Item Name: Crosstube Turning Detail

DART AEROSPACE LTD		Work Order:	101165
Description: Crosstube Assembly		Part Number:	D407-667-145
Inspection Dwg: D407-667-145 Rev: C		Page 1 of 2

DRAWING NO. D407-667-145	TITLE CROSSTUBE ASS'Y (407 HIGH FWD)	REV. C	DART AEROSPACE LTD ENGINEERING ORDER		D.E.O. NO. D407-667-145-C-1	SHEET NO. SHEET 1 OF 1	SCALE NTS
DRAWN 97	CHECKED ASS	MFG. APPR. 188	APPROVED WD		DE APPR. H		
DATE 11.07.15	DATE 11.07.22	DATE 11.07.22	DATE 11/07/22		DATE 11.07.21

DRAWING NO. D407-667-145		TITLE: CROSSTUBE ASS'Y (407 HIGH FWD)		REV. C		DART AEROSPACE LTD ENGINEERING ORDER		D.E.O. NO. D407-667-145-C-2		SHEET NO. SHEET 1 OF 1		SCALE NTS	
DRAWN AJS		CHECKED		MFG. APPR. <i>B</i>		APPROVED <i>140</i>		DE APPR. <i>140</i>					
DATE 12.08.02		DATE 12.08.02		DATE 12.08.02		DATE 12.08.02		DATE 12.08.02		DATE 12.08.02

DETAIL P
BONDING STRAP INSTALLATION 2 PL

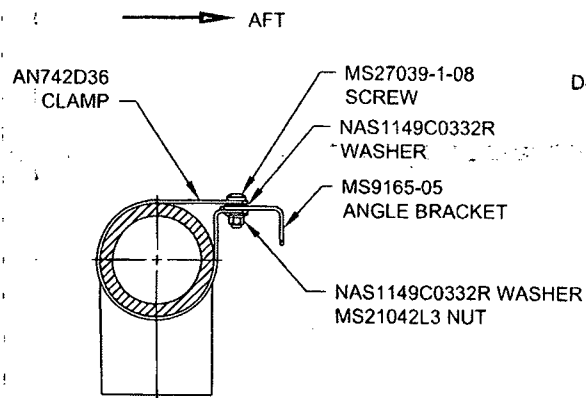
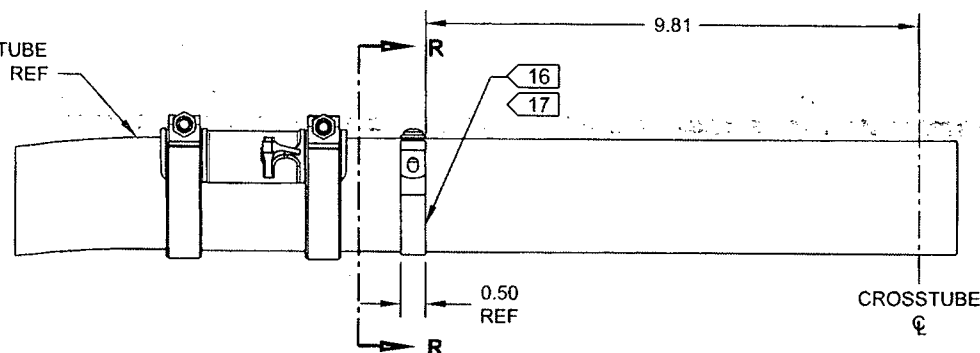
ADD ELECTRICAL GROUNDING STRAP

ITEM	QTY	PART NUMBER	DESCRIPTION
1	X	D407-667-145	CROSSTUBE ASSEMBLY (407 HIGH FWD)
⚡			
10	2	AN742D36	CLAMP
11	2	MS9165-05	ANGLE BRACKET
12	2	MS21042L3	NUT (OR MS21042-3)
13	2	MS27039-1-08	SCREW
14	4	NAS1149C0332R	WASHER (OR AN960C10L)

- 16) MASK AREA UNDER CLAMP PRIOR TO PAINTING
- 17) SEAL EDGES WHERE AN742D36 CLAMP MEETS WITH THE CROSSTUBE USING SIKAFLEX-241/-291 OR MIL-S-8802 CLASS B2 OR PROSEAL 890 SEALANT
- 18) PERFORM RESISTANCE CHECK TO ENSURE MAX RESISTANCE IS 10 MILLIOHMS
